RHODE ISLAND DEPARTMENT OF TRANSPORTATION

I-195 Relocation – Contract 16 – Providence River Pedestrian Bridge

NOTICE TO PROSPECTIVE BIDDERS

ADDENDUM NO. 8 Prospective bidders and all concerned are hereby notified of the following changes in the Plans, Specifications, Proposal and Distribution of Quantities for this contract. These changes shall be incorporated in the Plans, Specifications, Proposal and Distribution of Quantities, and shall become an integral part of the Contract Documents.

DESIGNED BY: ME
CHECKED: AN
DATE: 10/09/14
SHEET: V2_117
OF: V2_163

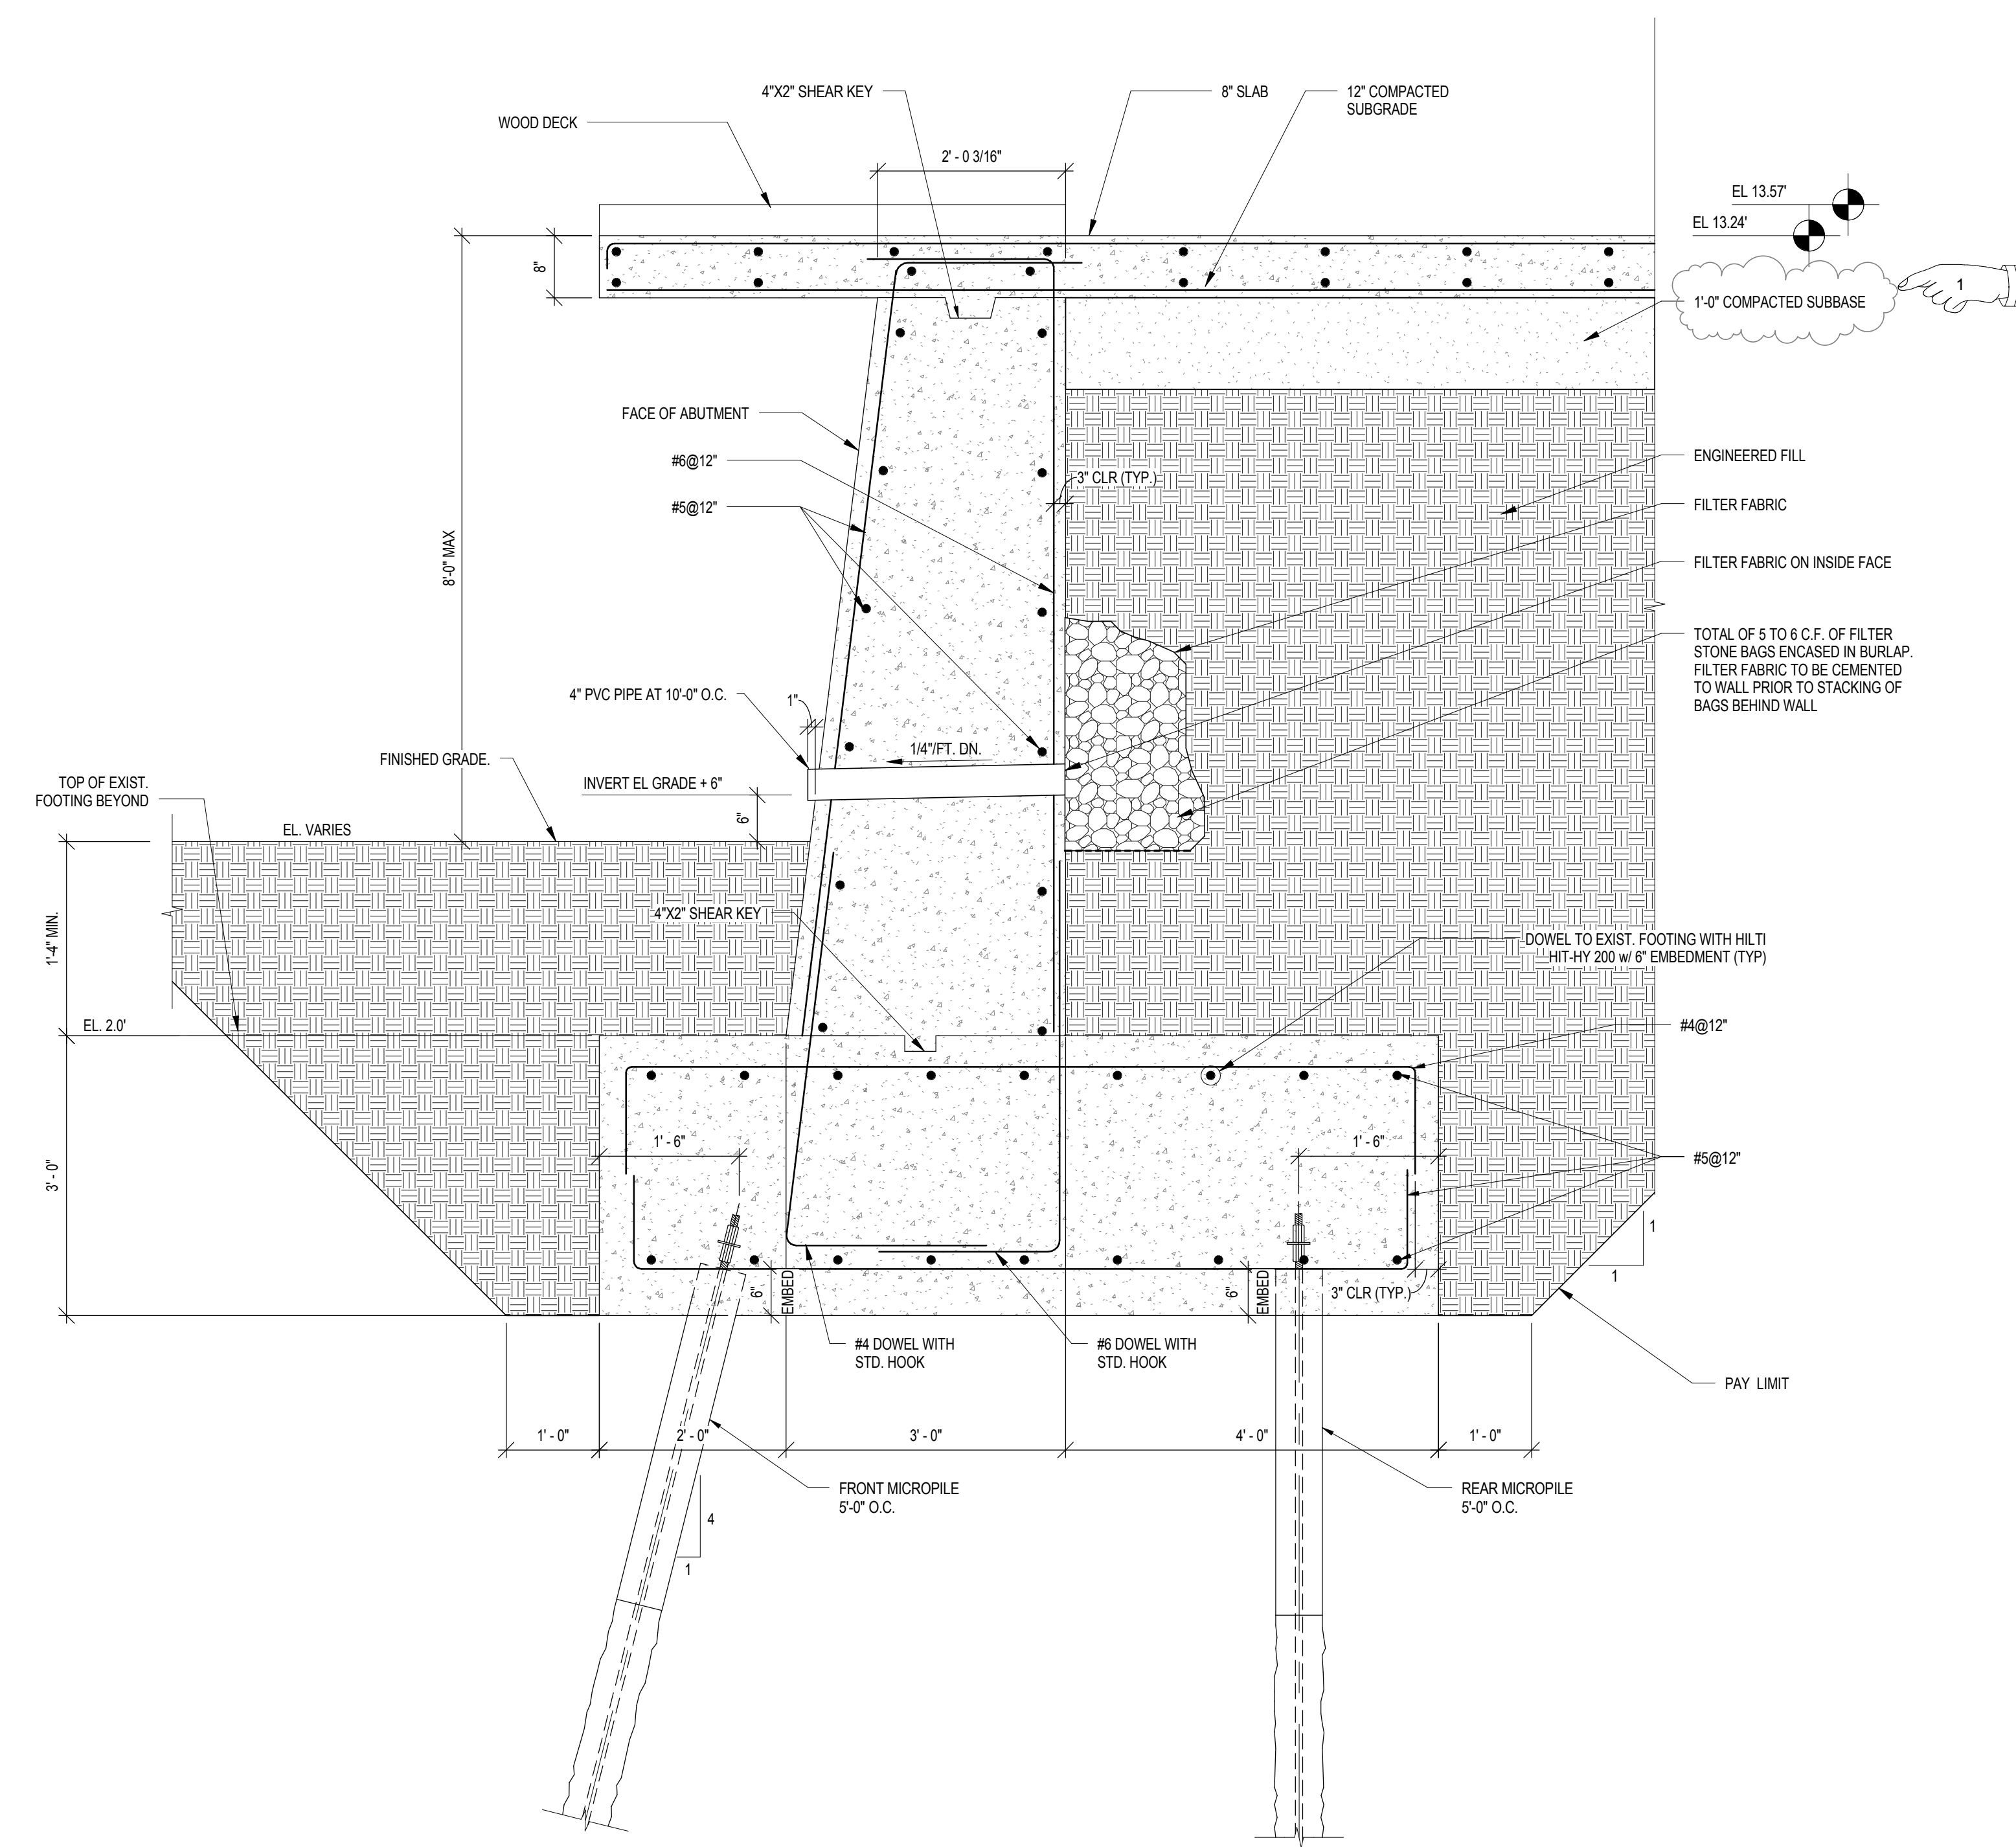
Delete Sheet V2_117 in its entirety and replace it with sheet V2_117(R-1) attached to this Addendum No. 8. A callout for the subbase has been revised.
